Access Compliance Report

Public Rights-of-Way

(Curb Ramps)

Intersection ID: 22153	Main Street: PUDDINGSTONE CV	Cross Street: STOCKTIE RD	Location:	N
ADA ID: C39E390D9B43	Ramp Type: BlendTrans1	Initial Pass/Fail: Fail	Overall Compliance: No	Severity Score: 10

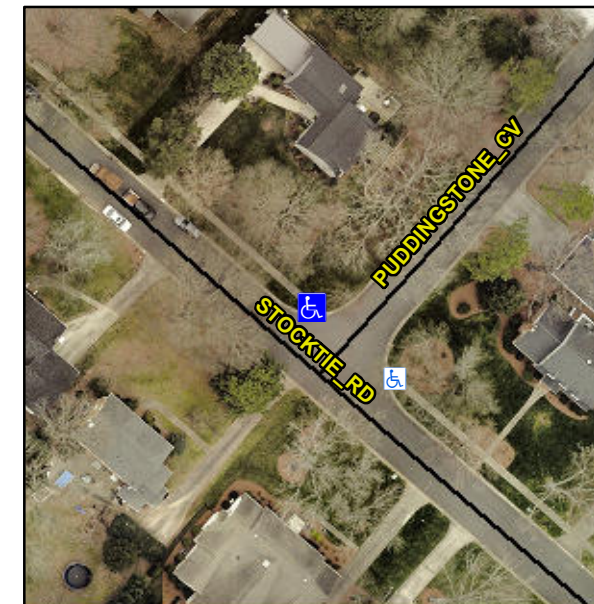
Not Found, R304.5.1, R304.5.3

Compliance	Description	Data	Compliance	Description	Data
N/A	Ramp Length (in)	61.0	Yes	BlendTrans Slope (%)	2.5
No	Ramp Width (in)	37.0	No	BlendTrans XSlope (%)	4.5
N/A	Flare Type LT	N/A	N/A	Flare Type RT	N/A
N/A	Flare Slope LT (%)	N/A	N/A	Flare Slope RT (%)	N/A
N/A	Flare Traversable LT?	N/A	N/A	Flare Traversable RT?	N/A
N/A	Landing Length (in)	N/A	N/A	DWS Provided?	N/A
N/A	Landing Width (in)	N/A	N/A	DWS Contrast?	N/A
N/A	Landing Slope (%)	N/A	N/A	DWS Length (in)	N/A
N/A	Landing X Slope (%)	N/A	N/A	DWS Full Width?	N/A
N/A	Landing Curb? (Y/N)	N/A	N/A	DWS Offset (in)	N/A
N/A	Shared Landing?	N/A			
N/A	Gutter Ponding?	N/A	N/A	Gutter Slope (%)	N/A
N/A	Gutter Lip Ht (in)	N/A	N/A	Gutter X Slope (%)	N/A
N/A	Painted X Walk1?	No	N/A	Painted X Walk2?	No
	X Walk 1 Direction	To SW		X Walk 2 Direction	To SE
	X Walk 1 Width (in)	N/A		X Walk 2 Width (in)	N/A
	X Walk 1 Slope (%)	3.4		X Walk 2 Slope (%)	6.6
	X Walk 1 X Slope (%)	5.6		X Walk 2 X Slope (%)	1.6

N/A	Ramp inside XWalk1?	N/A	N/A	Ramp inside XWalk2?	N/A
	Road Slope (%)	3.4		Clear Space?	N/A
	Road X Slope (%)	7.4	N/A	Clear Space to XWalk (in)	N/A
N/A	Any Obstructions?	N/A	N/A	Storm Grate/Utility Hazard?	N/A
	Obstruction Type			Storm Grate/Utility Type	
		N/A			N/A
			Yes	Surface Condition? (G/P)	Good
			No	Curb Slope (%)	10.2

Remove & Replace Curb Ramp With Two New Directional Ramps or Equivalent.
